IEEE P802.18 Radio Regulatory Technical Advisory Group (RR-TAG)

Proposed Response to MIIT of China Consultation on "Ultra- Wideband (UWB) Equipment Radio Management Regulations"							
Date: 2023-01-24							
Author(s):							
Name	Company	Address	Phone	email			
Dries Neirynck	Ultra Radio Ltd						
Ben Rolfe	Blind Creek Associates						
Riku Pirhonen	NXP Semiconductors			riku.pirhonen@nxp.com			
Billy Verso	Qorvo

Re: Consultation on the "900MHz Frequency Band Radio Frequency Identification (RFID) Equipment Radio Management Regulations (Draft for Comments)" and "Ultra Wideband (UWB) Equipment Radio Management Regulations (Draft for Comments)"

Figure 1: Comparison of the power spectrum density mask between the proposed regulation of China MIIT (i.e., "Proposed mask") and the requirements defined in IEEE Std 802.15.4-2020 [1] for IEEE HRP UWB PHY channels 8 and 10 (i.e., "ch8" and "ch10").

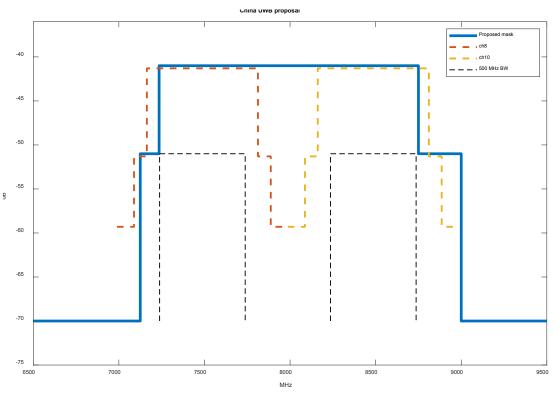
Figure 1 shows the power spectral density masks between the proposed regulation and those defined in [1] for IEEE HRP UWB PHY channels 8 and 10. Note that Channel 9 is left out intentionally to improve the clarity of the figure.

Figure 1 illustrates two issues with the proposed power spectrum density mask with respect to the IEEE Std 802.15.4-2020. First, the power spectrum density mask defined in IEEE Std 802.15.4-2020 does not fit inside the proposed limits. Secondly, the -10 dB minimum bandwidth is defined to be 500 MHz without any extra spectrum to take into account the roll-off. The figure shows that meeting the minimum bandwidth requirement (staying above the dotted black line of "500 MHz BW") and, at the same time, staying within the proposed emission limits (under blue line of "Proposed mask") using the UWB channels defined by [1], is impossible with a practical implementation.

Given the center frequency of the IEEE HRP UWB PHY channel 5 is equal to 6489.6 MHz, the European rules define a frequency separation of 489.6 MHz from the center frequency to the band edge with -70 dBm/MHz limit. In order to enable use of the IEEE HRP UWB PHY channel 8 with the center frequency of 7488 MHz in China, the corresponding separation for channel 8 would require the lower -70 dBm/MHz band edge not to be higher than 6998 MHz. It is worth noticing that the -51 dBm/MHz limit does not exist in [4]. If it is considered necessary, it should not be stricter than the spectrum mask defined in the IEEE Std 802.15.4-2020, which would set the -51 dBm/MHz limit at 7163 MHz or below.

Similar expansion of the available band would be needed for the upper UWB band limit to enable IEEE HRP UWB PHY channel 10 with the center frequency of 8486.4 MHz, where a -70 dBm/MHz limit would be set to 8976 MHz or above, and the possible -51 dB/MHz limit at or above 8810 MHz.

Frequency range	EIRP limit	
Below 6998 MHz	-70 dBm/MHz	
6998 MHz – 7163 MHz	-51 dBm/MHz	
7163 MHz – 8810 MHz	-41 dBm/MHz	
8810 MHz – 8976 MHz	-51 dBm/MHz	
Above 8976 MHz	-70 dBm/MHz

Figure 2: Power spectrum density of the IEEE HRP UWB PHY channel 5 with center frequency of 6489.6 MHz (i.e., "ch5") and the European band edge limits at 6 GHz (i.e., "Europe")

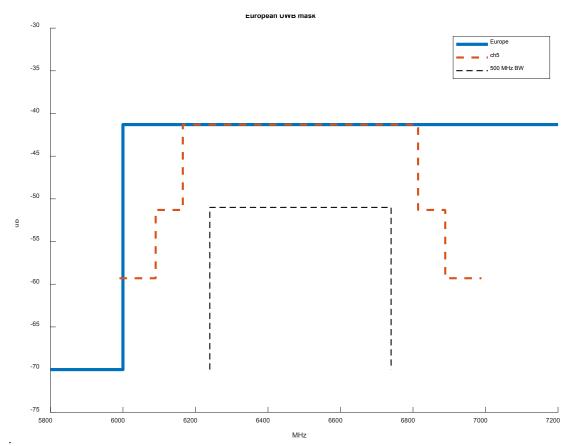
For comparison, Figure 2 shows the power spectral density mask of channel 5 and the existing European regulatory emission limits [4] at band edge. This could be used as a reference for possible limits. The European limit at 6 GHz is not very relaxed by any means, but it does allow a feasible implementation. The 500 MHz minimum bandwidth limit is presented in the figure for reference, but it is not a requirement in Europe.
